## International Isotopes Inc.

Subject: Submittal of Responses to Requests for Additional Information (RAI)  
TAC L32739.

The following document is provided as a response to the US Nuclear Regulatory Commission RAIs pertaining to the International Isotopes Fluorine Products Inc. December 30, 2009 application to license a depleted uranium hexafluoride de-conversion and fluorine extraction process facility.

(1) Official Responses to Human Factors RAIs

**Figure 4-1 IIFP Facility Human Factors Engineering Design Process**

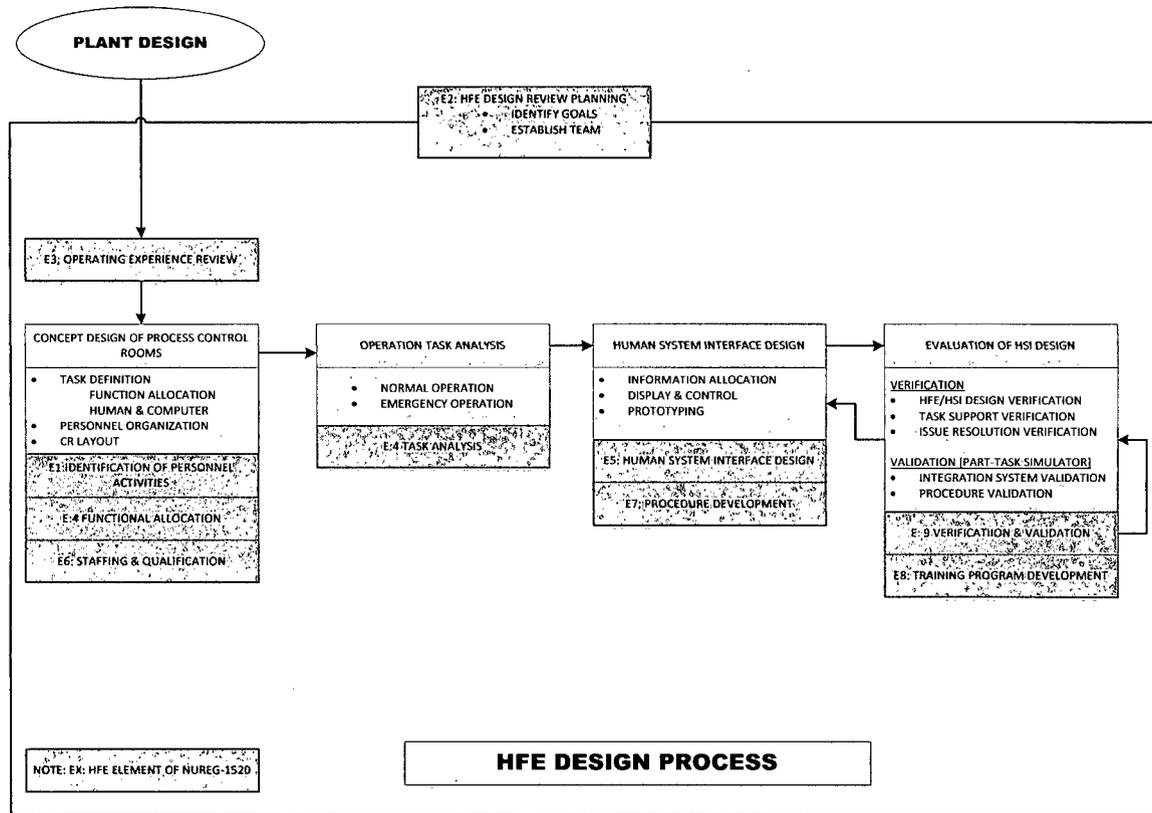
*HF-1. Criterion A, Appendix E of NUREG-1520 states that the applicant should appropriately identify the personnel activities that are considered IROFS such that a reviewer can understand the actions, human-system interfaces involved, and the consequences. ISA Table 4-3 contains the Accident Sequence Summary and Risk Index for a number of potential events, many of which are either labeled "operator error" or which appear to involve human action. However, the human-system interfaces involved are not identified.*

- a. Identify the human-system interfaces involved in the accident sequences that include human actions, such that the impact on the IROFS can be evaluated.*

The HFE design process to be used for the IIFP Facility is depicted in Figure 4-1.
